ADDENDUM 2

Vestavia Hill Fire Station No. 4 Expansion

DATE: **August 12, 2026**

1 HARDSCAPE PLAN

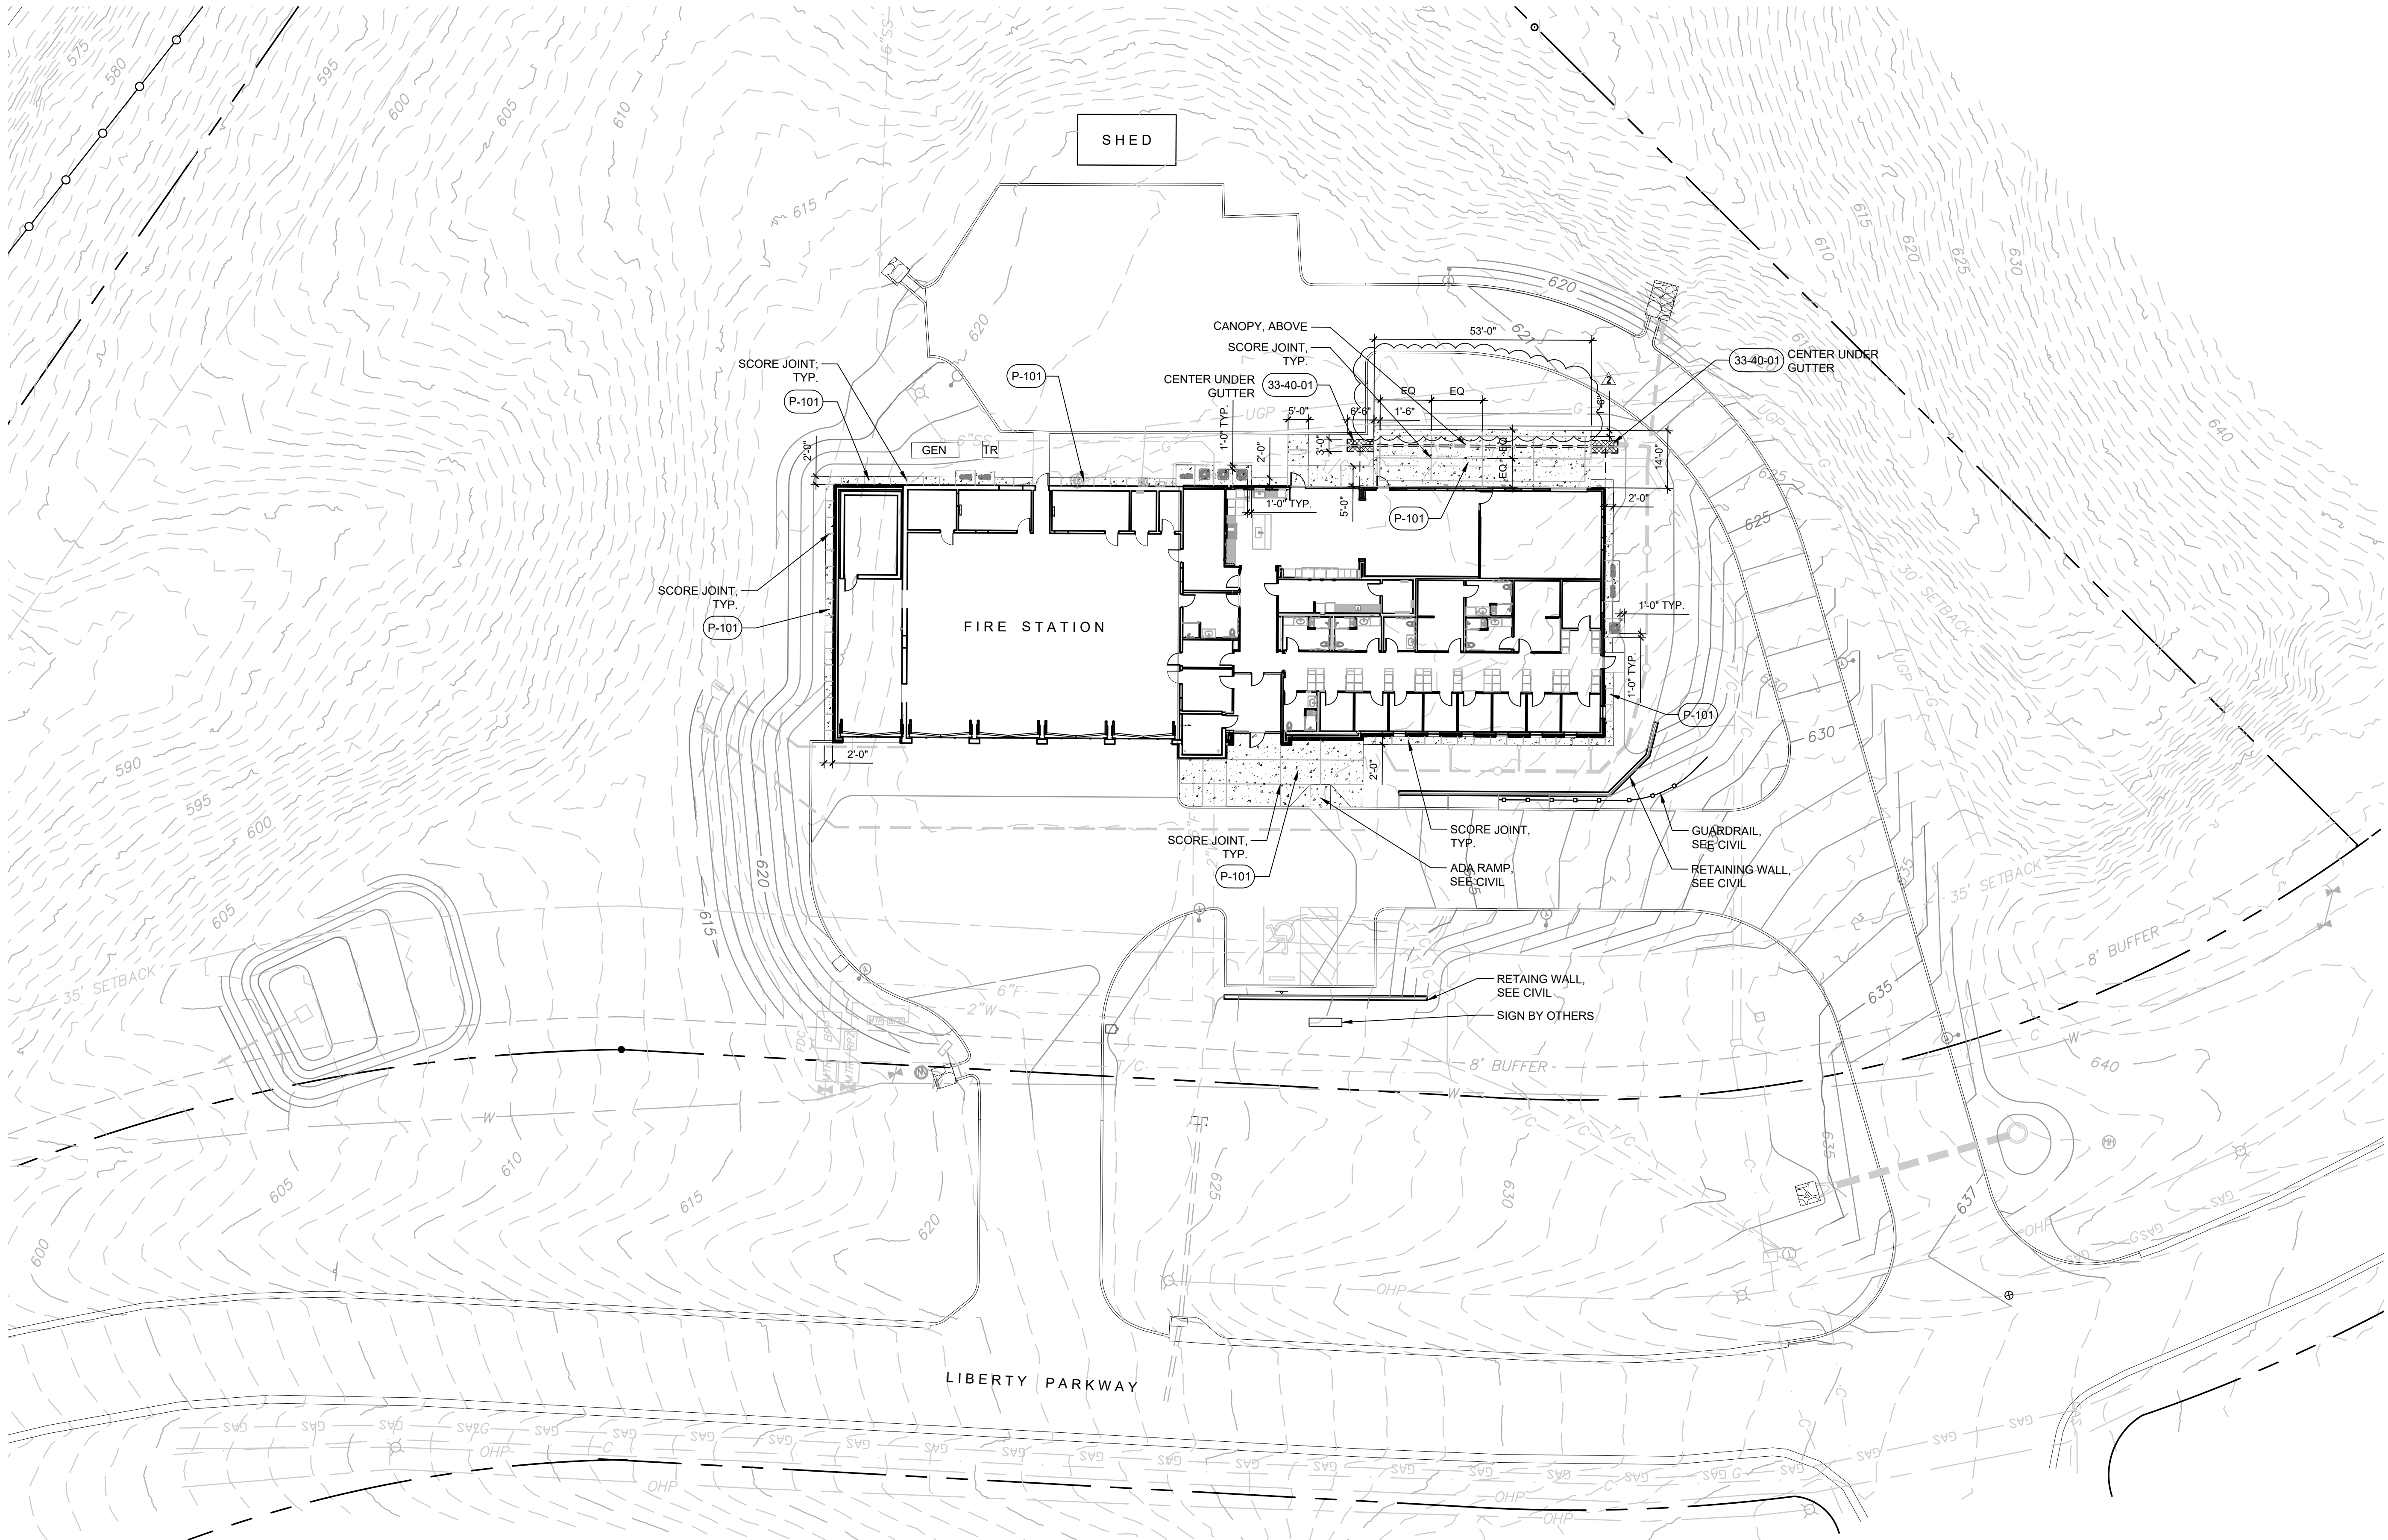
1. L-100 – IRRIGATION PLAN:
 - a. Reduced irrigation coverage to accommodate reduction of plant material
2. L-200 – HARDSCAPE PLAN & DETAILS:
 - a. Removed synthetic turf
3. L-300 – LANDSCAPE PLAN:
 - a. Removed all American Beautyberry (CAM)
 - b. Removed all Little Henry Sweetspire (IVS)
 - c. Removed 43 Don's Dwarf Waxmyrtle (MCD)
 - d. Added 1585 SF of Empire Zoysia

FLOOR AND FOUNDATION PLAN

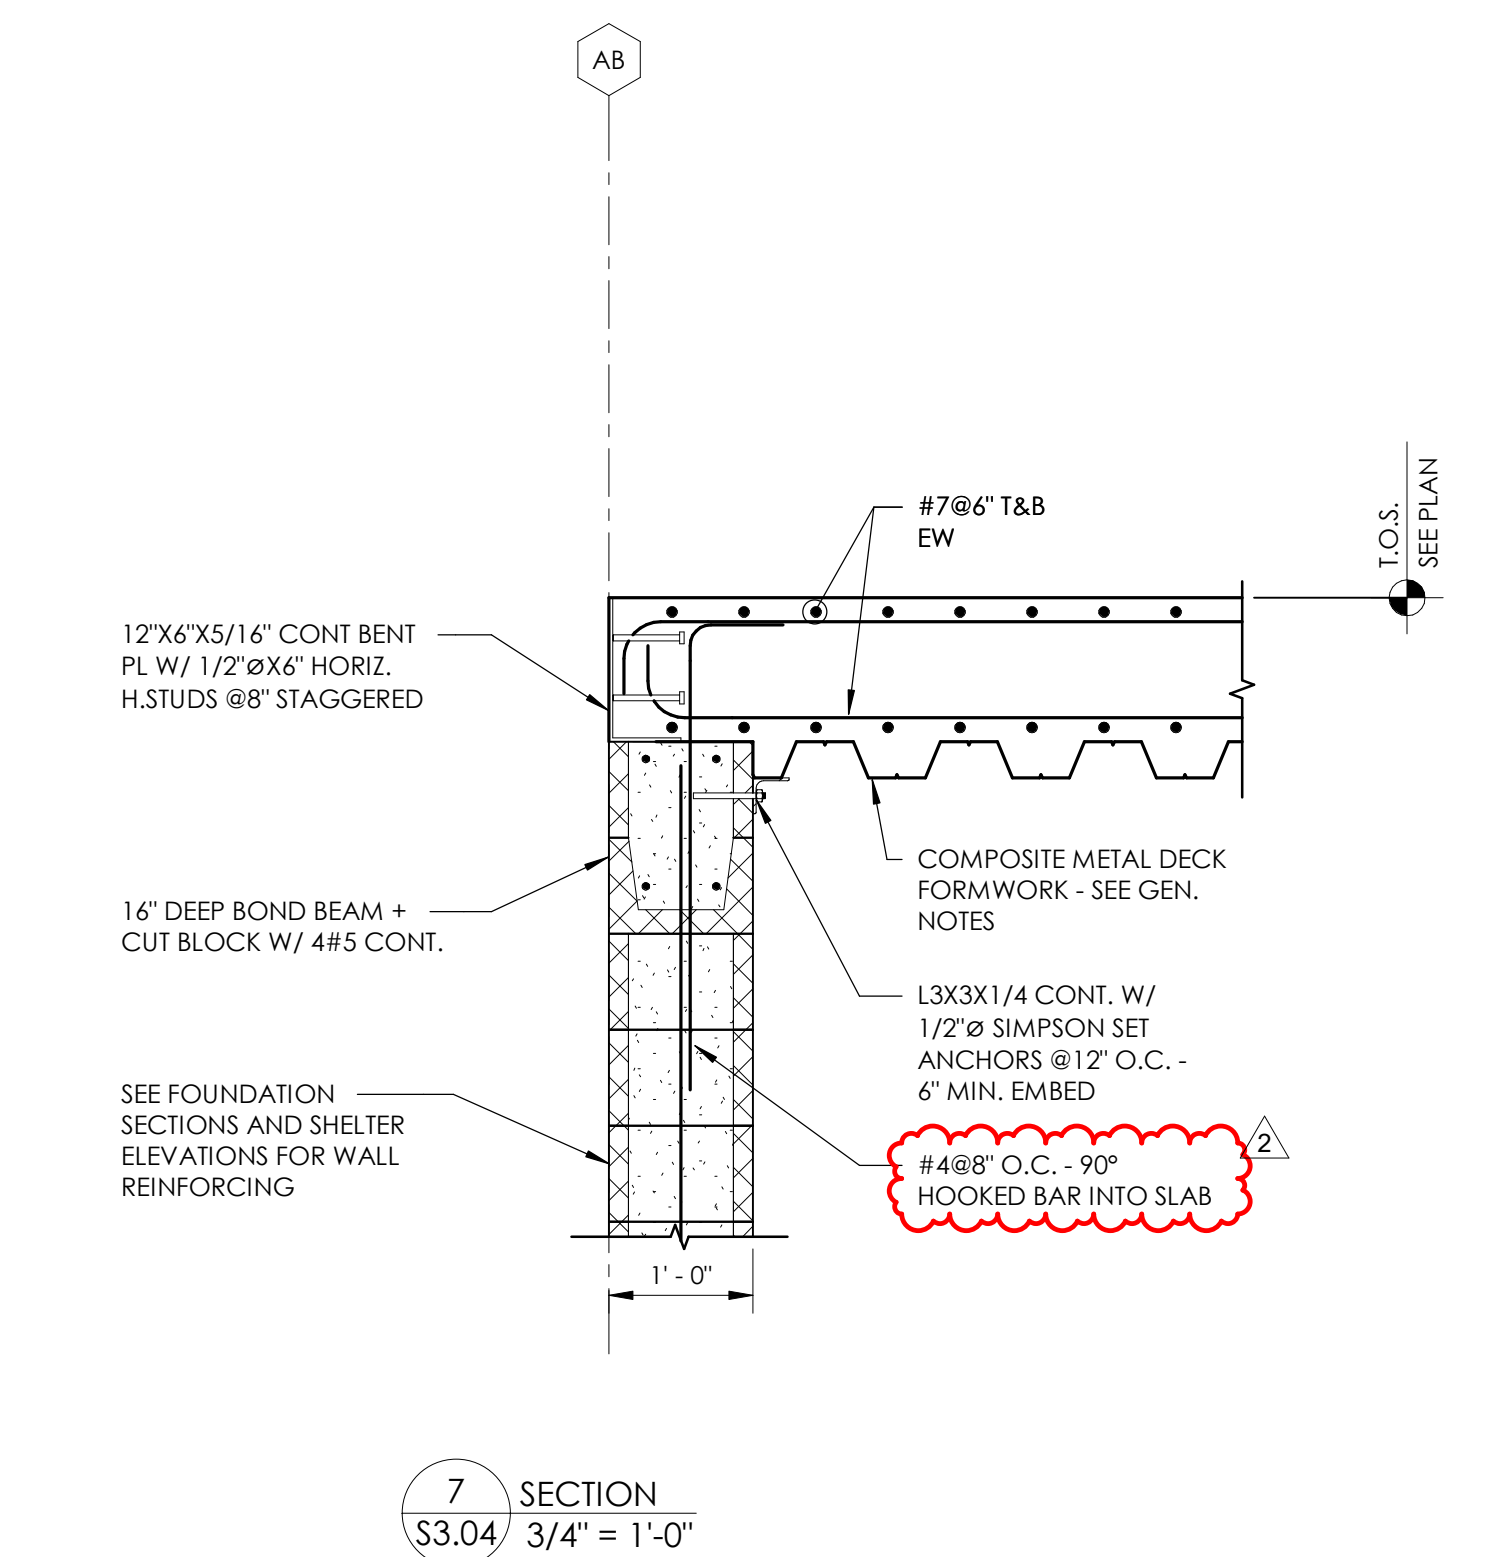
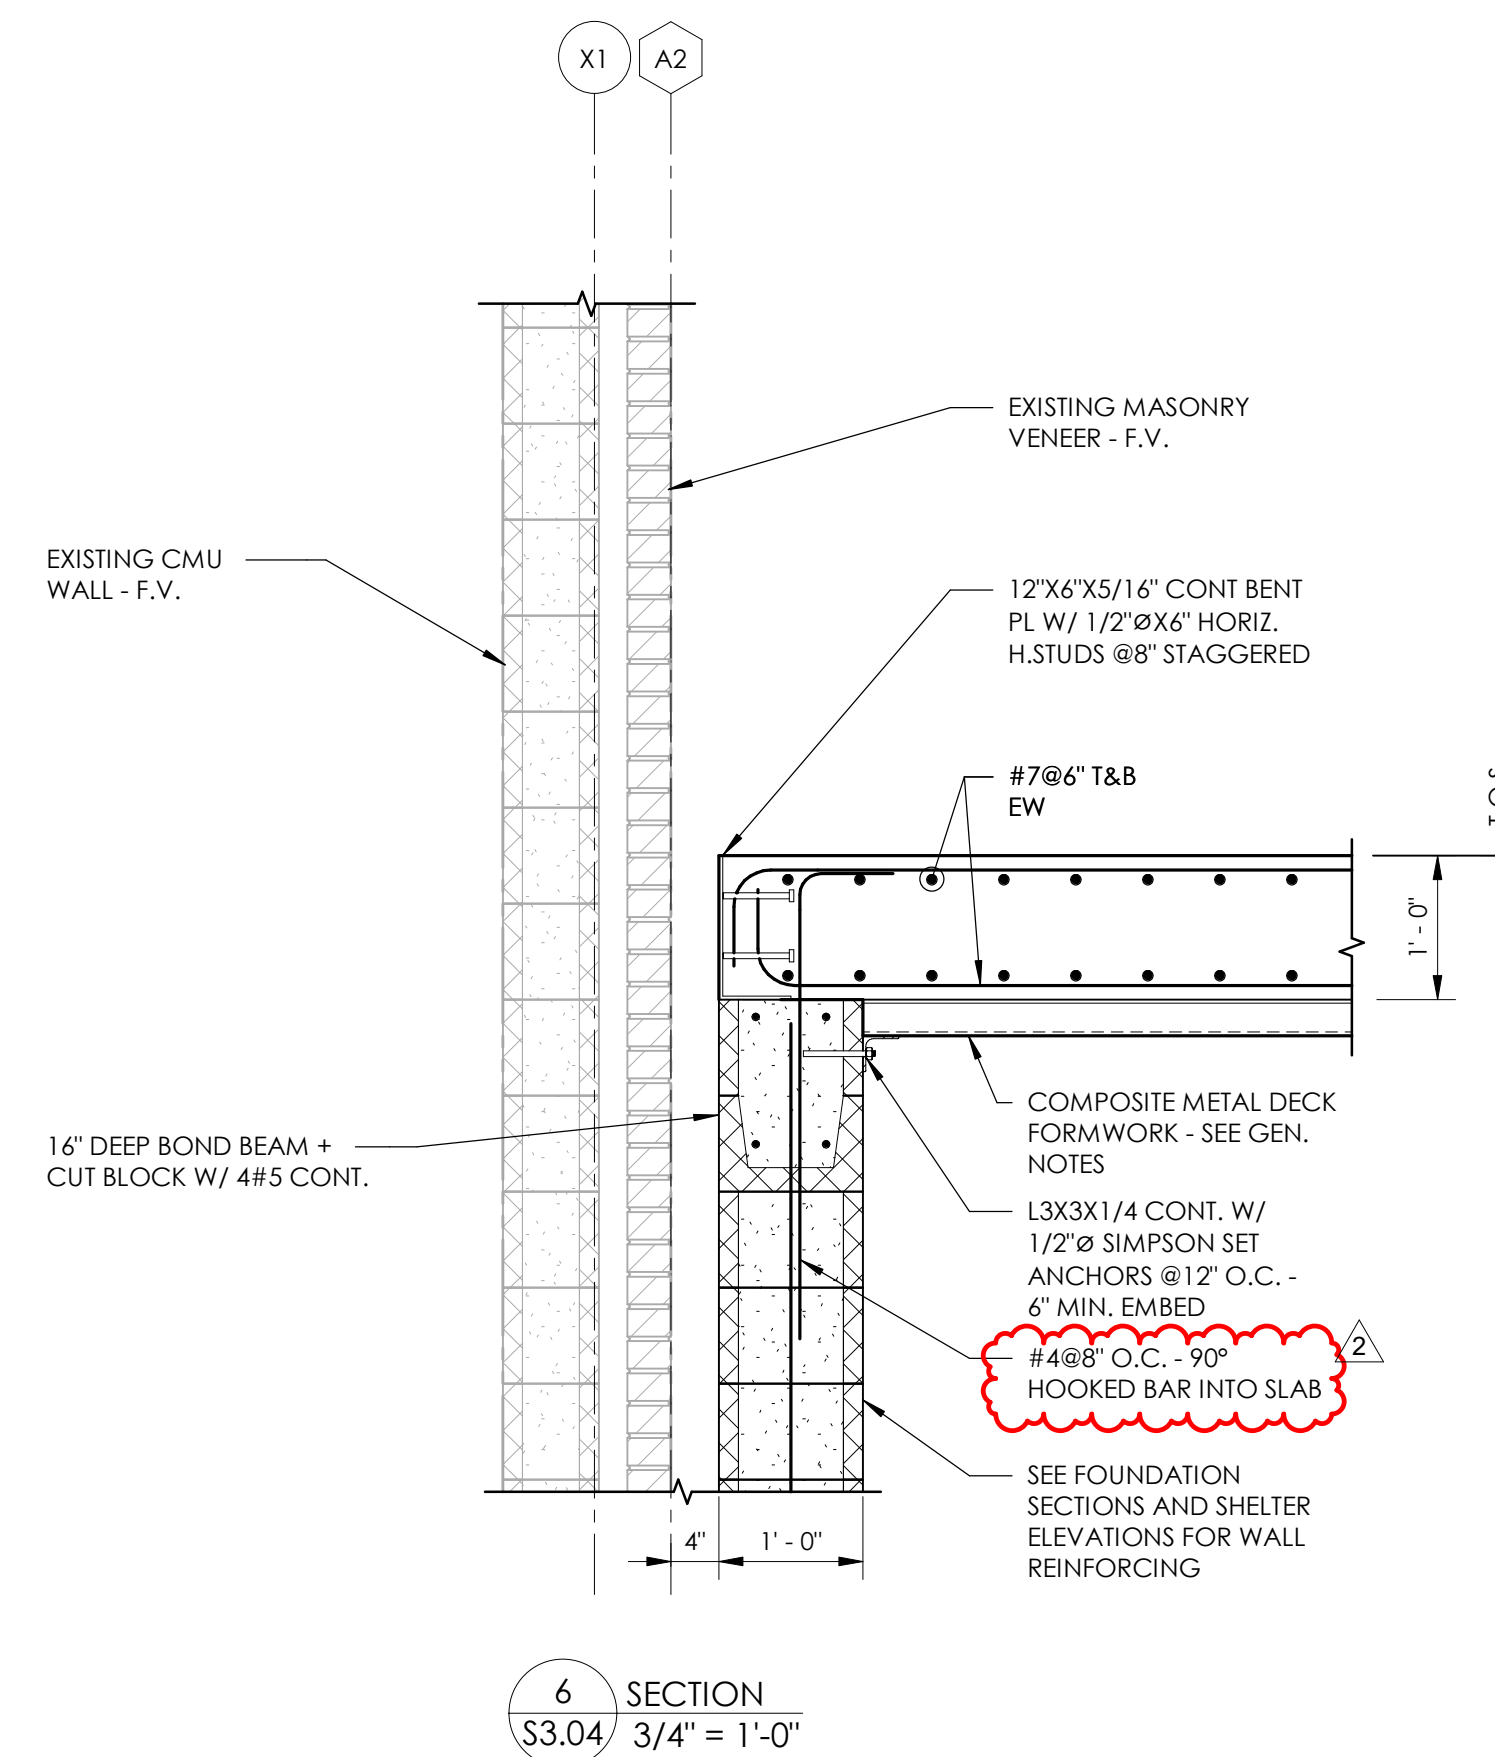
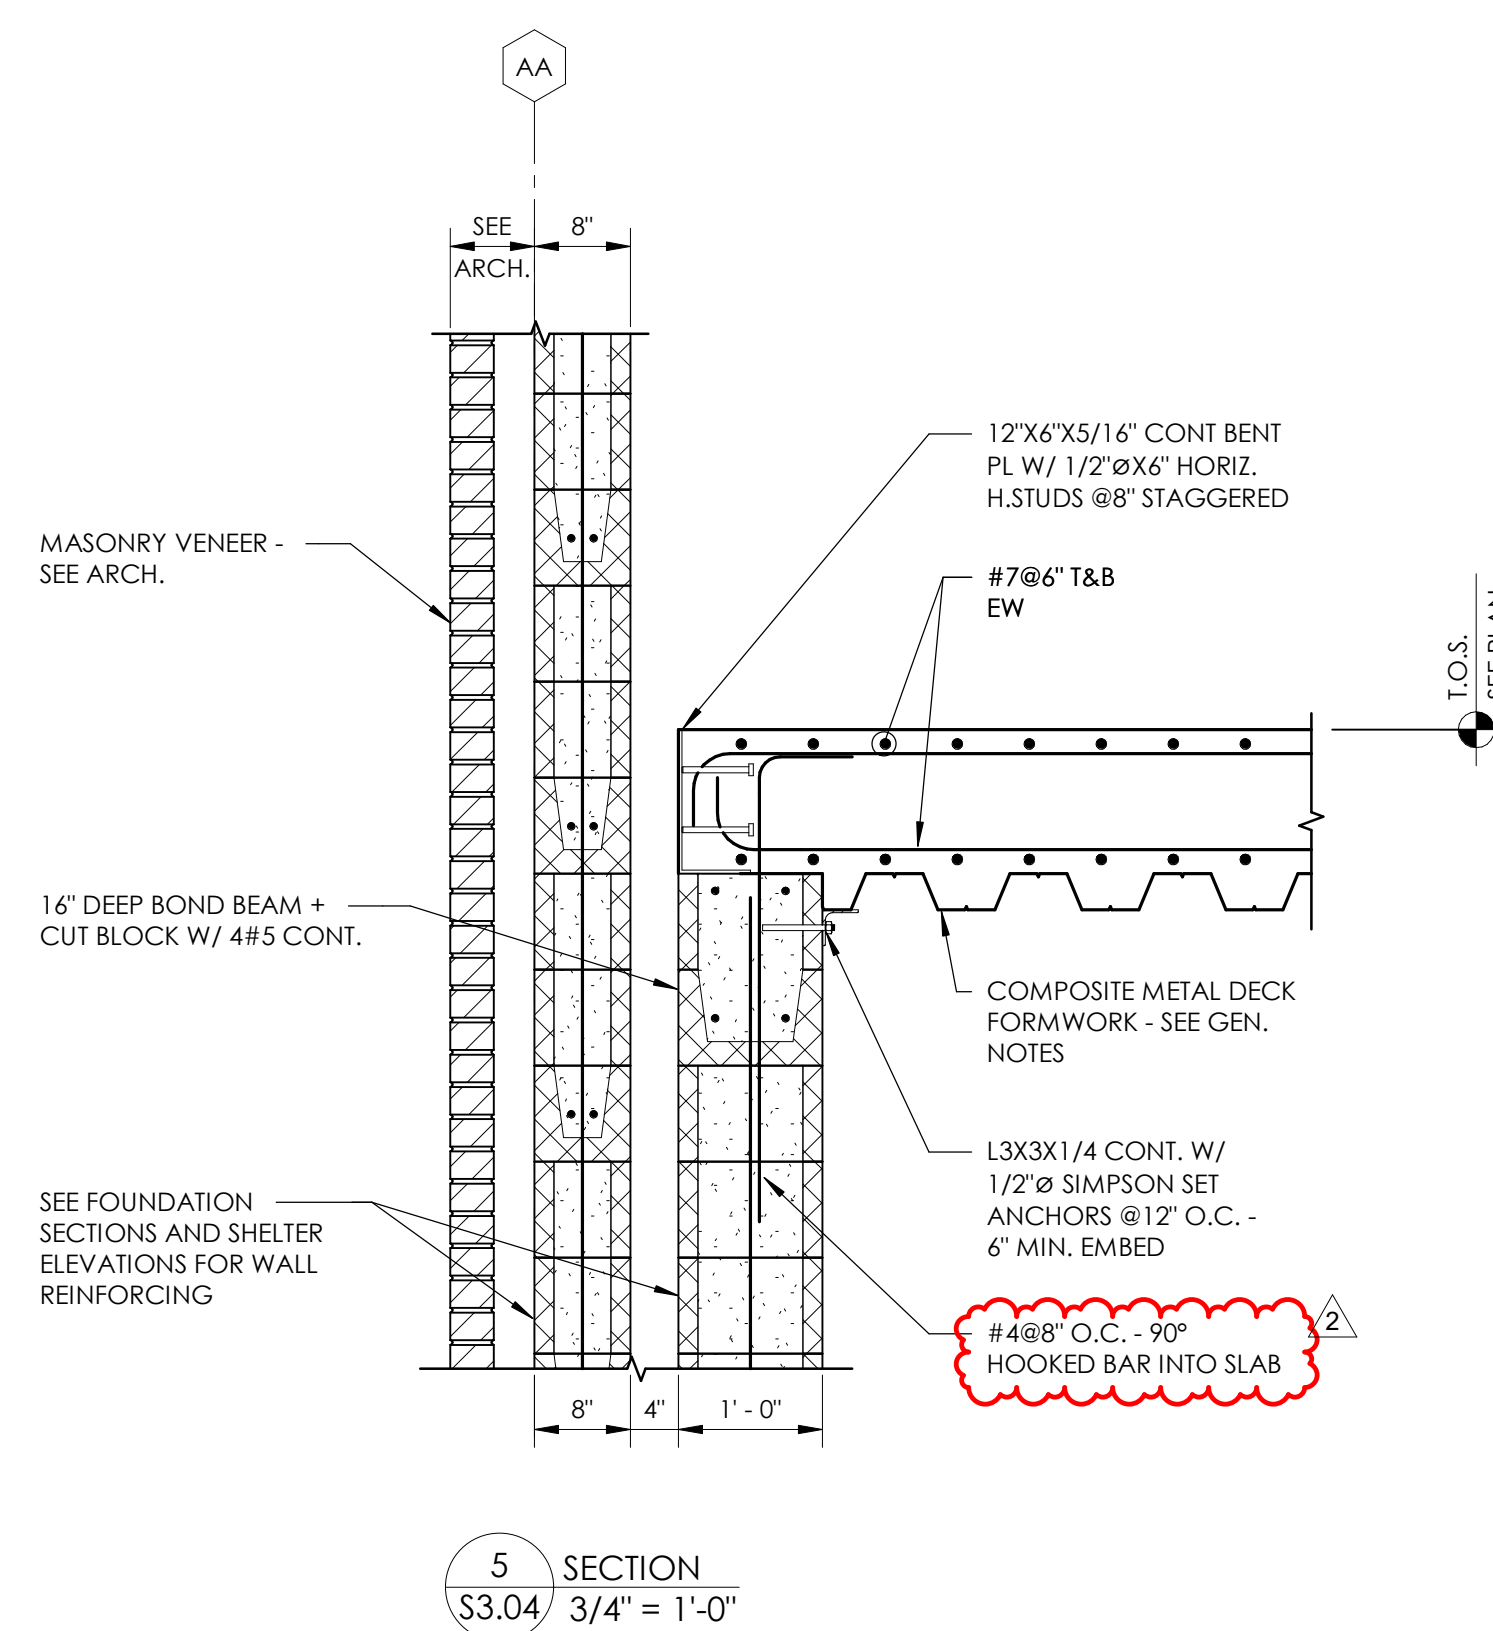
1. S1.01 – GENERAL NOTES:
 - a. General notes revised per Storm Shelter Peer Review Comments. See Revision Clouds.
2. S2.01 – FLOOR AND FOUNDATION PLAN:
 - a. “Similar” note added to sections and foundation dimensions added per Bidder RFI #1 comment received 07/13/26.
3. S3.04 – SECTIONS:
 - a. Note revised per Storm Shelter Peer Review Comments. See Revision Cloud.
